The Association of Pool & Spa Professionals appreciates this opportunity to comment on the proposed revisions to the proposed 45 Day Language-California Title 24, Pool Systems and Equipment Installation Standards. As the world's largest pool and spa trade association, we offer the following comments of particular interest to the APSP.

# California Title 24, Pool Systems and Equipment Installation

45-Day Language Review & Revision Suggestions

By Association of Pool and Spa Professionals (APSP) Technical Committee

Figure 1

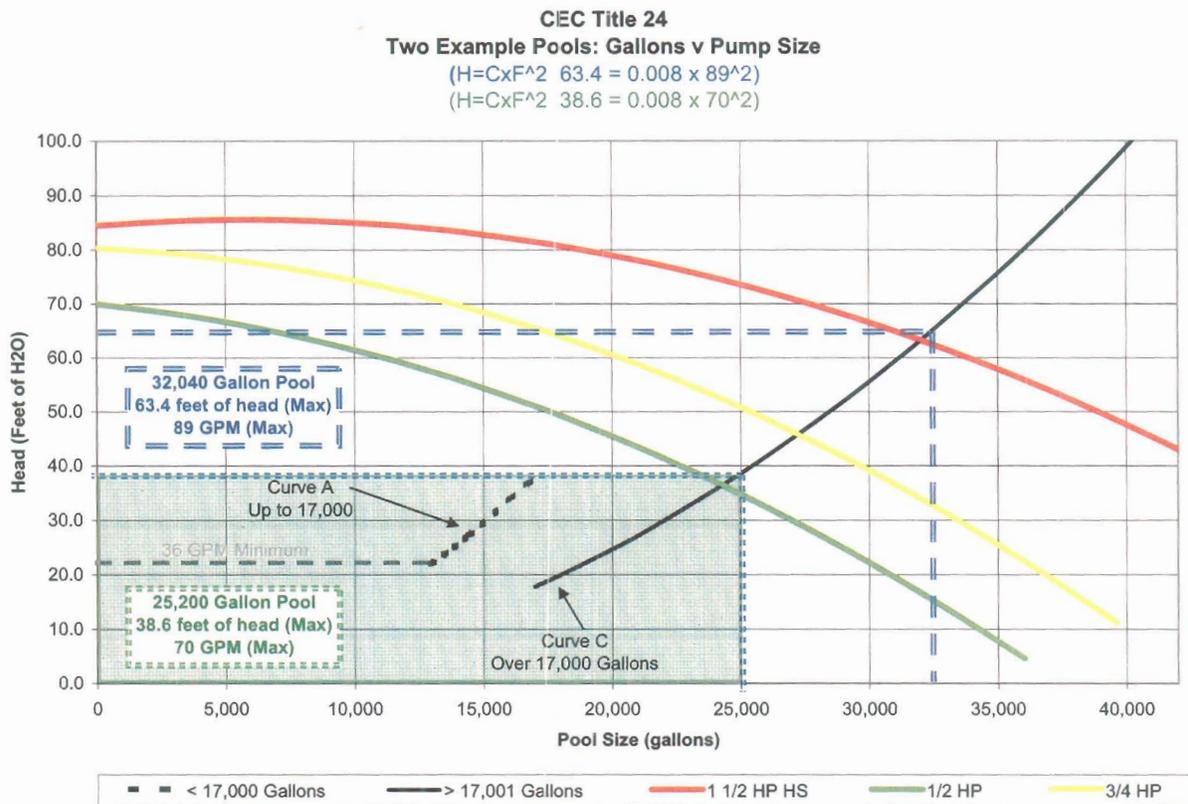
Two example pools are evaluated using the Title 24 formula. The first is a 32, 040 gallon pool. Using the formula the pump curve must cross Curve C below 63.4 feet of head and 89 GPM. All three pumps in this example are acceptable for use on this pool. The second example is a 25, 200 gallon pool. The formula says the pump curve must cross Curve C below 38.6 feet of head and 70 GPM. Only the 1/2 HP pump crosses Curve C below the formula point, the other example pumps are too large.

An important point is Title 24 does not limit head once the pump is installed, only GPM is limited by the six-hour turnover minimum, or 36 GPM, whichever is greater.

In reality, the first three bullet points drive the selection of the filtration pump based on a certified pump, the pool gallons, and the six hour turnover limit. This limits the size of the pump which can be used, however smaller pumps may be used as the formula establishes maximums, not minimums.

It should be noted that 36 GPM is the lowest filtration flow rate required, meaning the proposed regulations will not enforce the six hour turnover limit on pools less than 12,960 gallons (The horizontal extension of Curve A from zero gallons to 12,960 gallons, shown in Figure 1). The rationale being skimmers may not function adequately below the GPM.
